Illinois Tollway Standard Drawing Revisions

Section C Guardrail and Concrete Barriers		
Drawing	Modification Summary	Effective: 03-01-2026
C1-14	GALVANIZED STEEL PLATE BEAM GUARDRAIL	
Sheet 1	Foreslope and backslope dimensions in Guardrail Installation Details sections were revised for clarity	
C2-02	CONCRETE BARRIER SINGLE FACE, REINFORCED TL-4, L-SHAPE 44 INCH

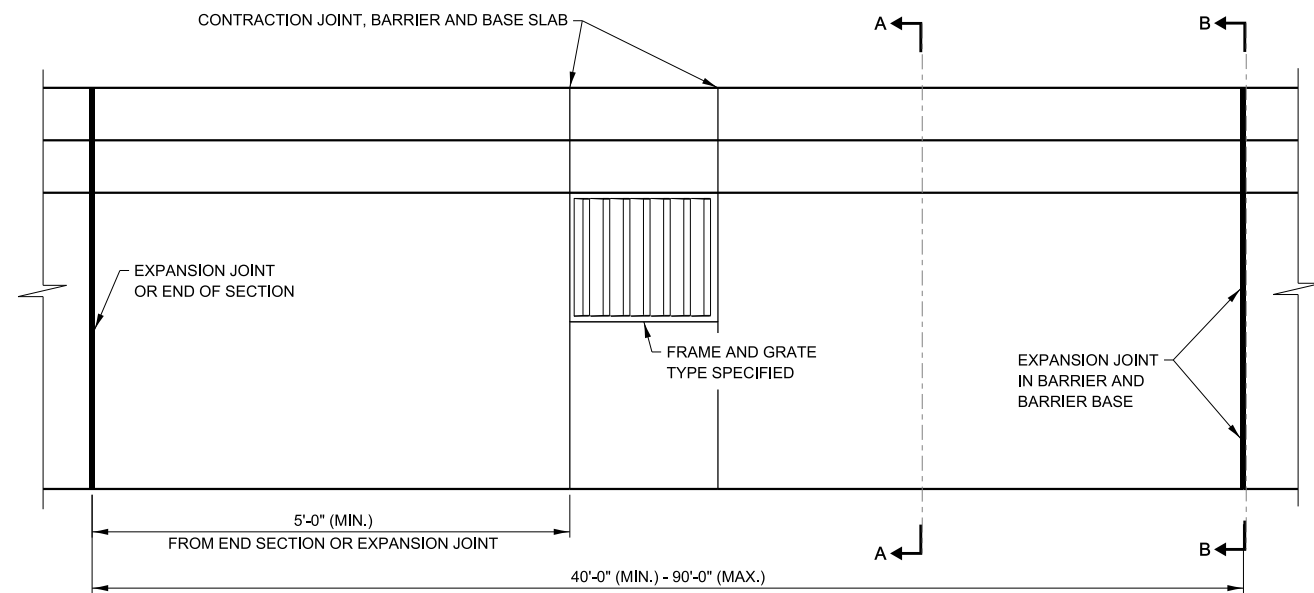
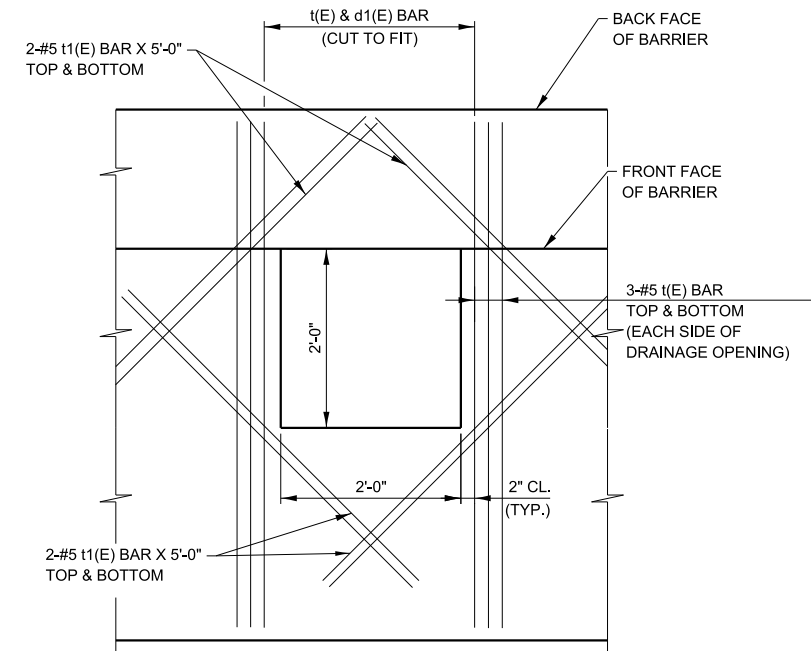
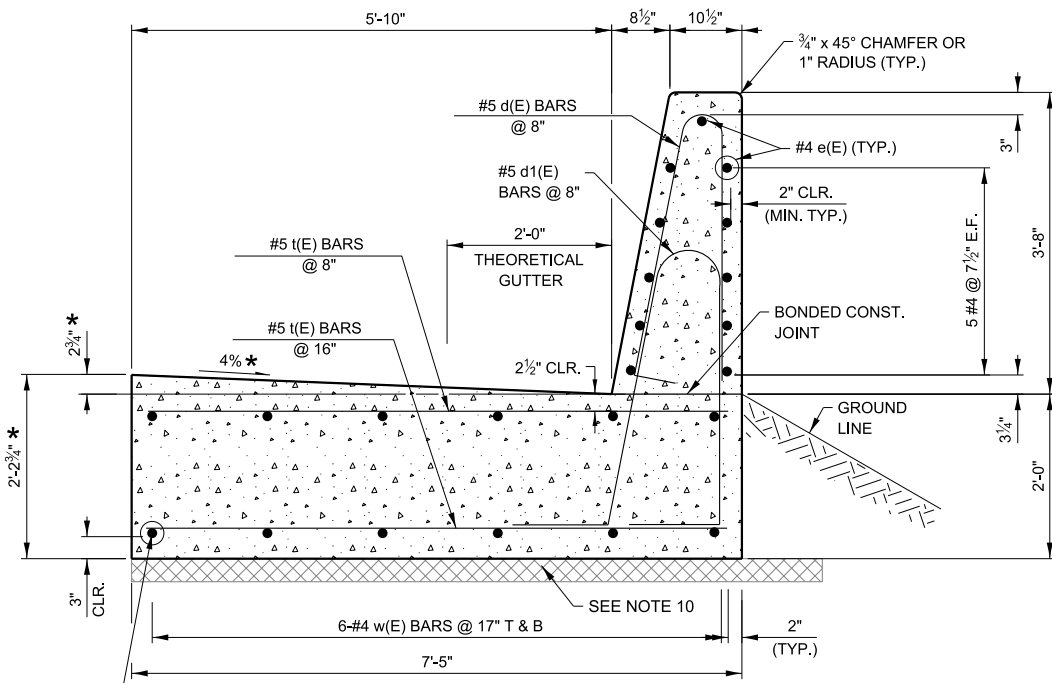
Sheet 1	Note 10 added to clarify subbase material under concrete barrier base	
C16-05	CONCRETE BARRIER SINGLE FACE, REINFORCED TL-5, L-SHAPE 44 INCH	
Sheet 1	Note 10 added to clarify subbase material under concrete barrier base	
C17-06	CONCRETE BARRIER SINGLE FACE, REINFORCED TL-5, 54 INCH

- WHEN SPECIFIED IN THE PLANS, THE BACKSIDE OF THE BARRIER BASE MAY BE LEFT EXPOSED A MAXIMUM OF 1', MEASURED FROM THE TOP OF THE BARRIER BASE.
- SUBBASE DIMENSIONS AND MATERIAL REQUIREMENTS UNDER CONCRETE BARRIER ARE SHOWN ON STANDARD B-24.

REVISIONS	
DATE	DESCRIPTION
03-01-2026	ADDED NOTE 10
03-01-2024	ADDED PJF BETWEEN BASE AND DRAINAGE STRUCTURES
03-01-2023	REVISED NOTE #1 AND REINF.
	DETAIL AT DRAINAGE STRUCTURES
03-01-2022	REVISED NOTES & CALLOUTS

CONCRETE BARRIER SINGLE FACE, REINFORCED TL-5, 54 INCH

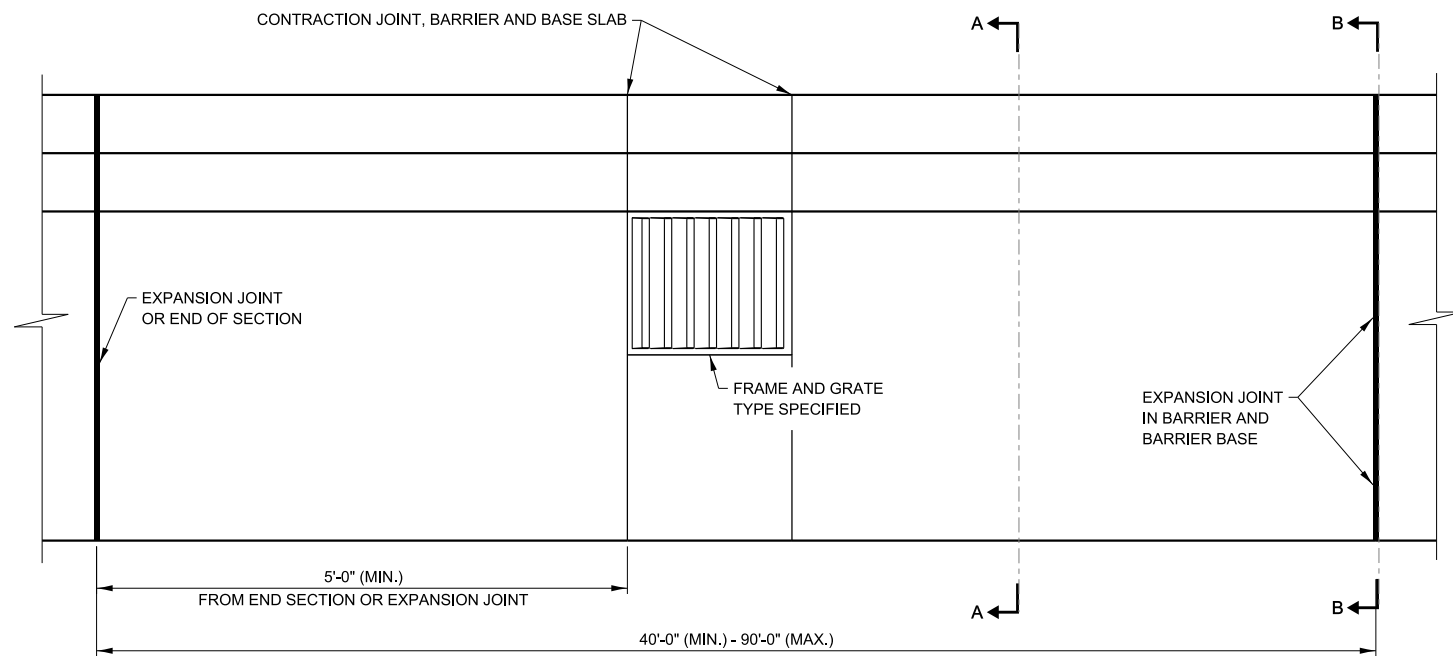
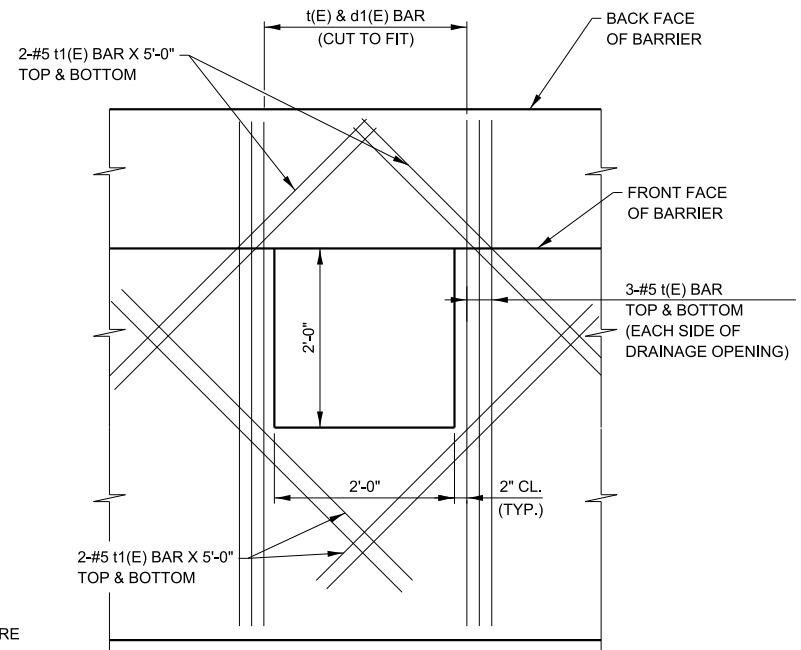
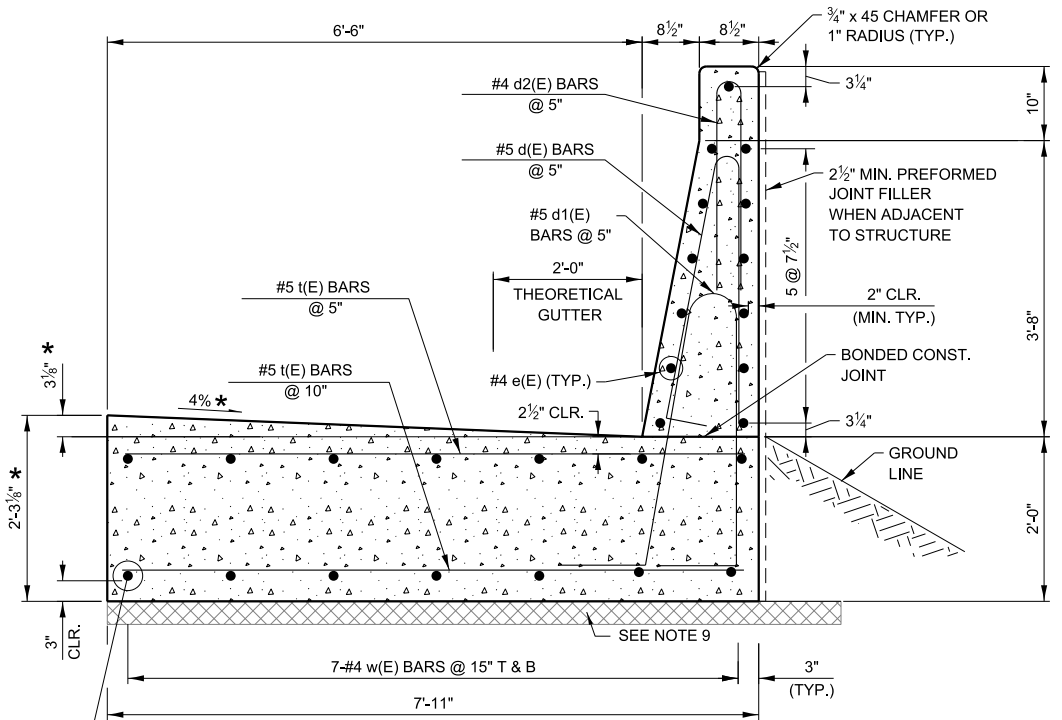
Sheet 1	Note 9 added to clarify subbase material under concrete barrier base

REVISIONS	
DATE	DESCRIPTION
03-01-2026	ADDED NOTE 9
03-01-2024	ADDED P/JF BETWEEN BASE AND DRAINAGE STRUCTURE
03-01-2023	REVISED REINF. DETAIL AT DRN. STRUCTURE. REMOVED NOTE 9
03-01-2022	REVISED NOTE 4.

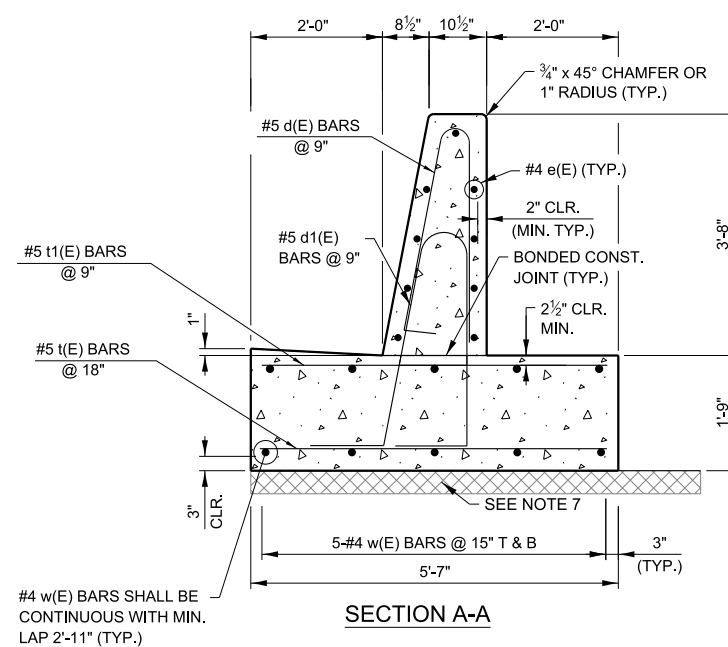
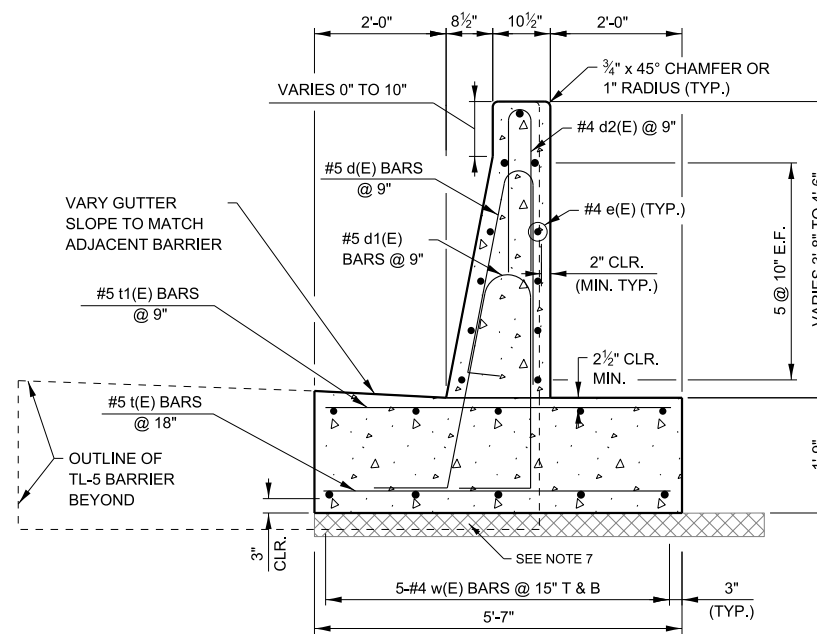
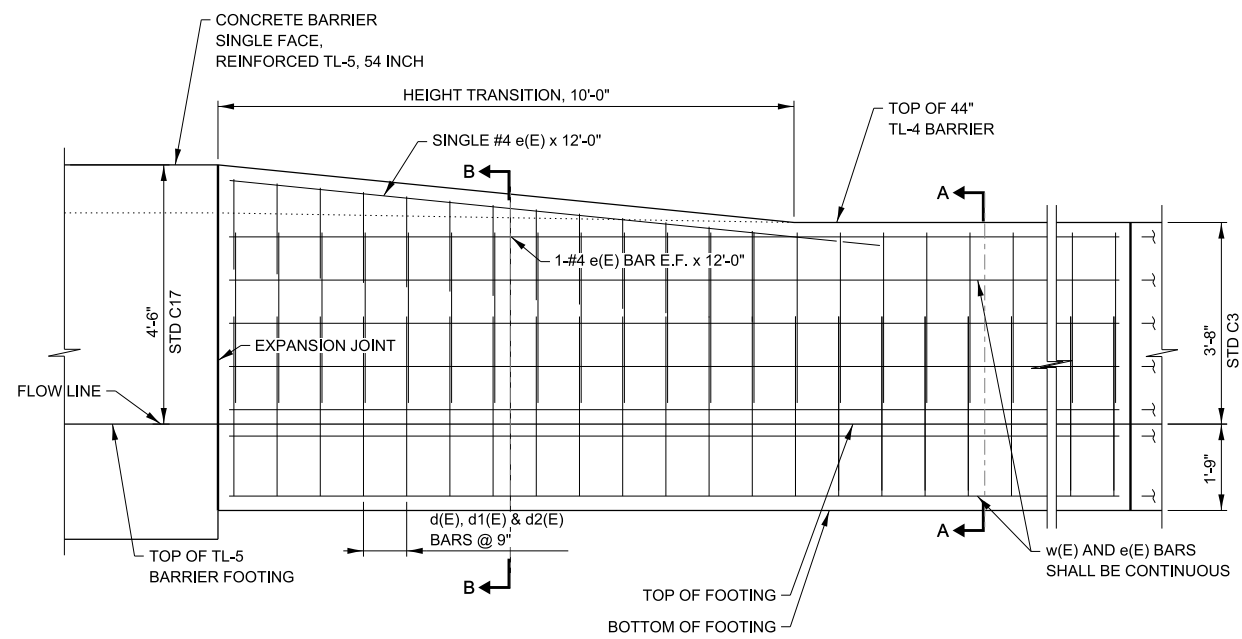
Section C Guardrail and Concrete Barriers		
Drawing	Modification Summary	Effective: 03-01-2026
C18-03	CONCRETE SHOULDER BARRIER HEIGHT TRANSITION, SINGLE FACE, TYPE SF-54	
Sheet 1	Note 7 added to clarify subbase material under concrete barrier base

REVISIONS	
DATE	DESCRIPTION
03-01-2026	ADDED NOTE 7
03-01-2022	REVISED NOTES
03-01-2021	REVISED REBAR LENGTH
